**Addendum for Bid
Oak Lane at Rivermont Traffic Signalization**

RE: Addendum **No. 1**

Bid No.: 13-828

SIGNAL DESIGN PLAN
FOR OAK LANE AT RIVERMONT AVENUE
LYNCHBURG, VIRGINIA

INTERSECTION PLAN SHEET

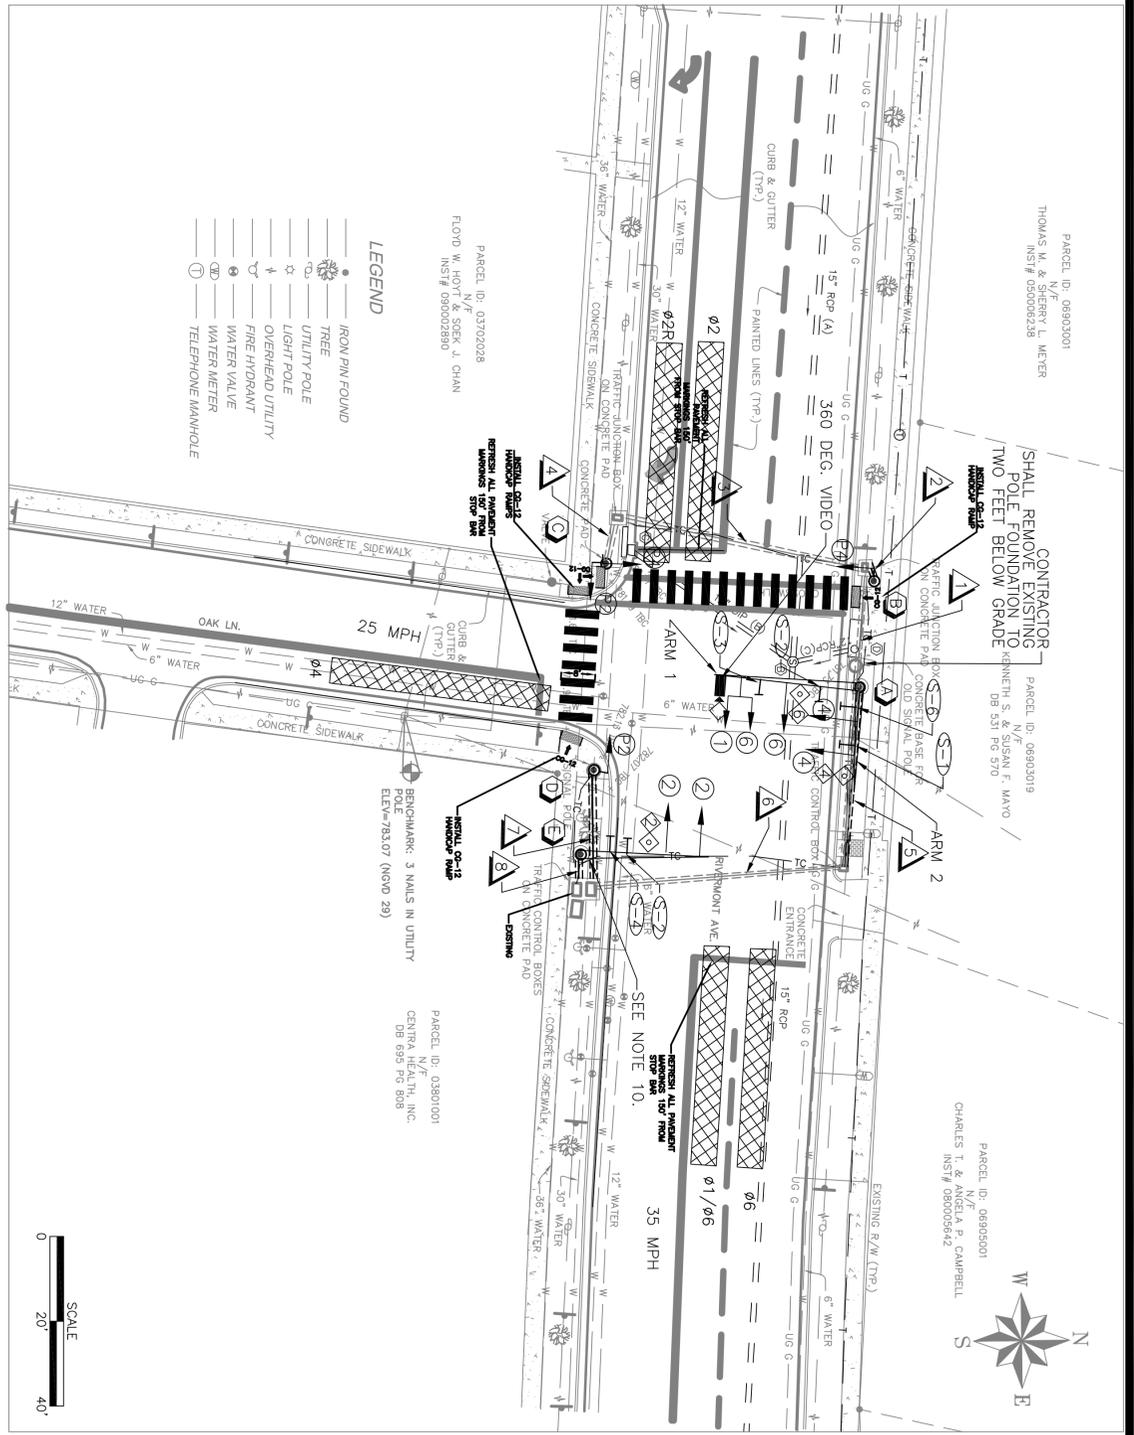
1. Change electric service from SE-5 pedestal mount to SE-3 mast pole mount.
 - Changed the electric service from SE-5 to mast pole mount SE-3.
2. Need a system ground installed.

- Ground rods in all j-boxes and #8 conductor bond wire from ground rod to ground rod.
Added the #8 conductor bond wire to conductor schedule and quantities.

3. Each ped push buttons needs its own individual 14 gauge 2-C cables. These 2-C cables need to be reflected in the conductor schedule.
 - Revised the 5C for the push button and head to a separate cable for each push buttons and heads (2C and 3C) in the conductor schedule and updated the quantities.

4. Video cable should be shown as cat-5 for Aldis camera system, and should be shown run in conduit runs 5 and 6 not run 8.
 - Revised the Conductor schedule.

5. Asterisk note on conductor schedule should read “** = per Aldis specifications”.
 - Updated the note.
6. What is to be done with the old mast pole foundation on the north side of rivermont ave. near new mast pole A? Will the contractor remove it?

- Added a note for the contractor to remove foundation to 2' below grade, and added a pay item to the quantities sheet.
7. See construction note 5. Ped signals are mounted on their own poles not on the mast arm poles.

- Revised note.
8. See construction note 9. All new conductors should be used. Using existing conduit is OK.
 - Revised note

NO.	DESCRIPTION	DATE	APP
1	CHANGED SERVICE FROM SE-5 TO SE-3 MAST POLE MOUNT.	2/23/23	
2	CHANGED ** NOTE TO ALDIS SPECIFICATIONS.	2/23/23	
3	ADDED CONSTRUCTION NOTE 17	2/23/23	
4	REUSED NOTE 5 AND NOTE 9.	2/23/23
